Stuertz Infeed - Reinforcing Forward Clamp Energy Chain System

Instructions on reinforcing the energy chain on Stuertz infeed table forward clamp system

Redesign of Main Energy Chain Tray Holder

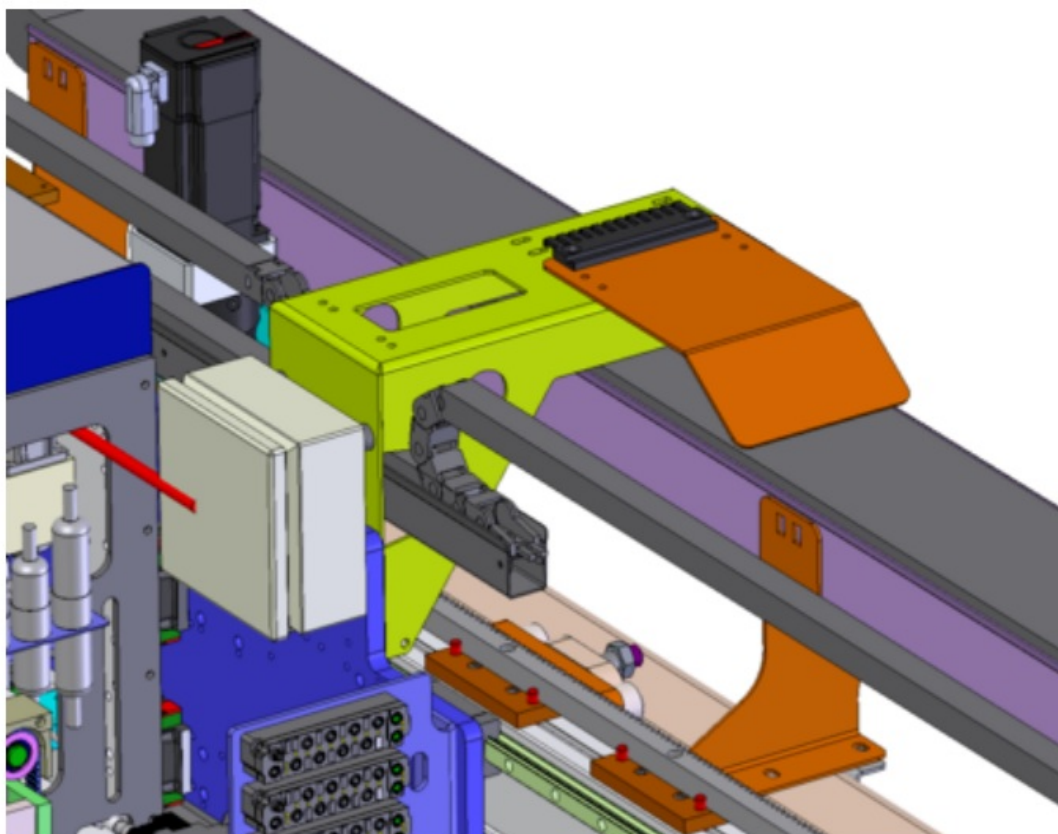
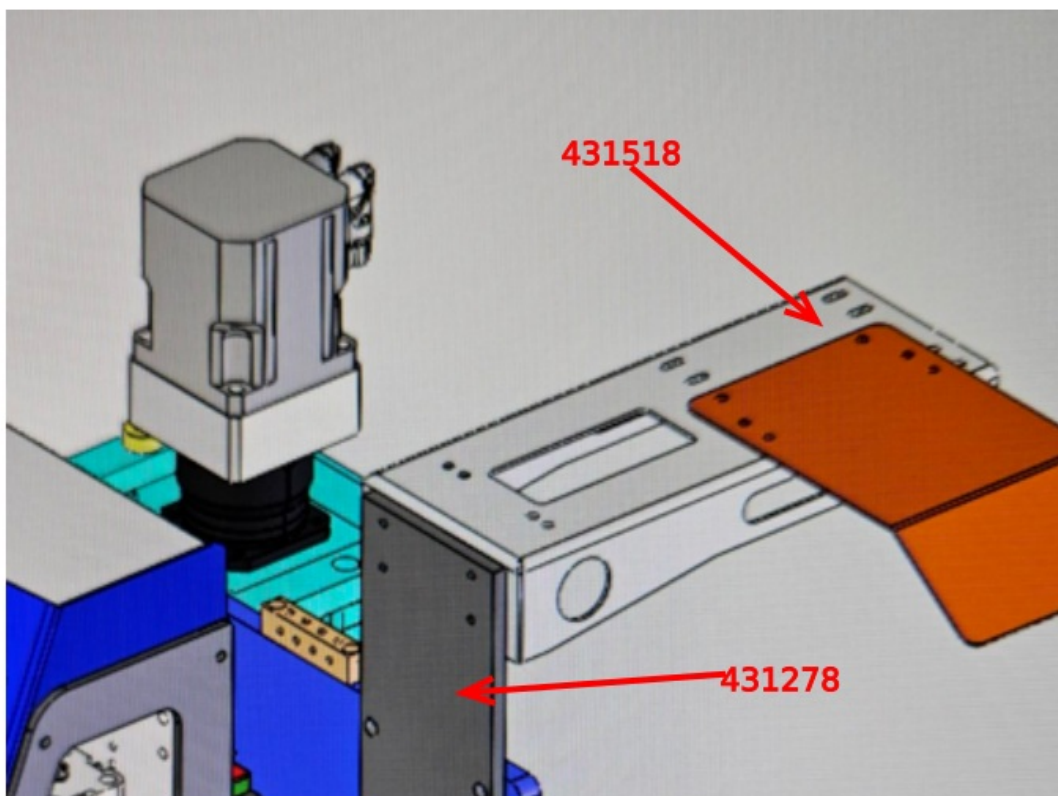
On A2030, the energy chain tray for the forward clamp was splitting along a seam and breaking. This, in turn put the tray in misalignment with the hole in the main energy chain tray mount. This led to a catastrophic failure of the system.

The original part and mounting plate have been replaced with 431278 and 431518

Reinforcing Plates for the Energy Chain Tray

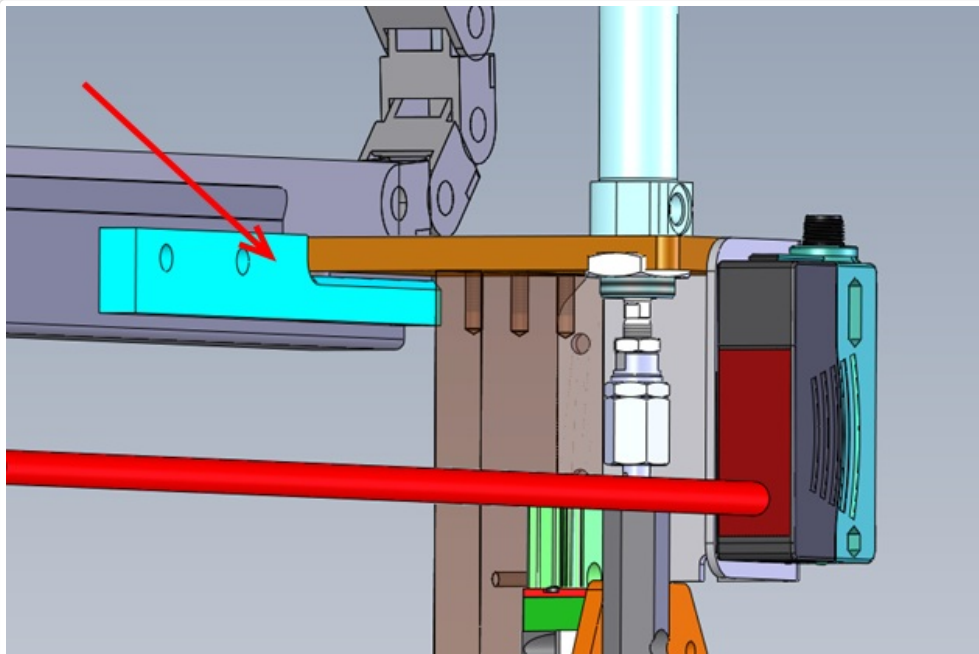
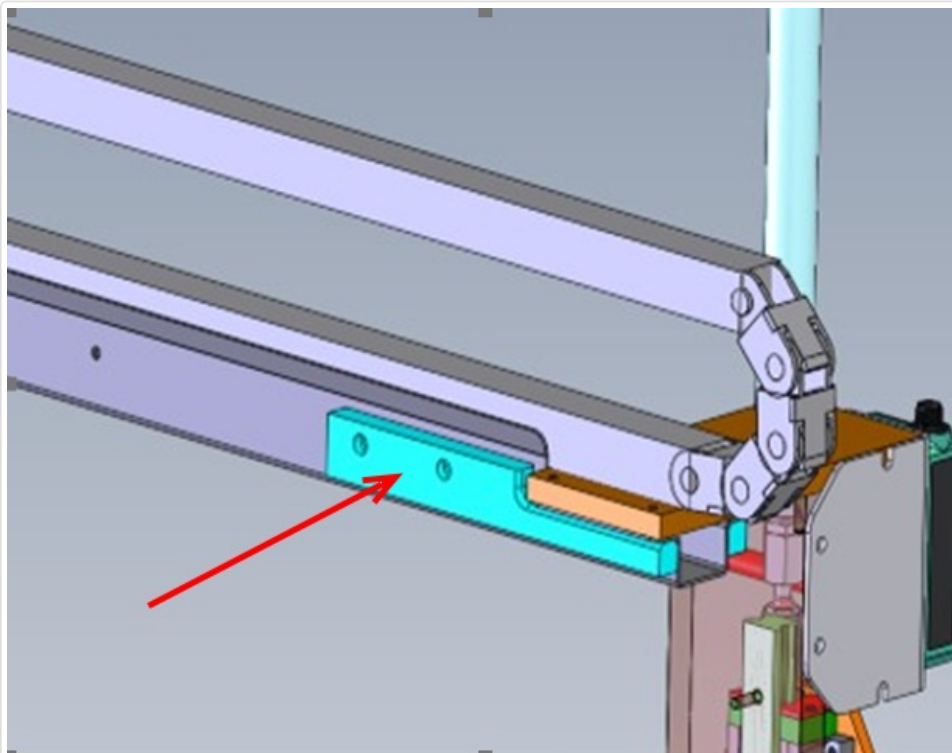
Part number 431805 has been designed to fit alongside each side of the energy chain tray (421312) to stabilise and strengthen the joint
Page 4 / 5
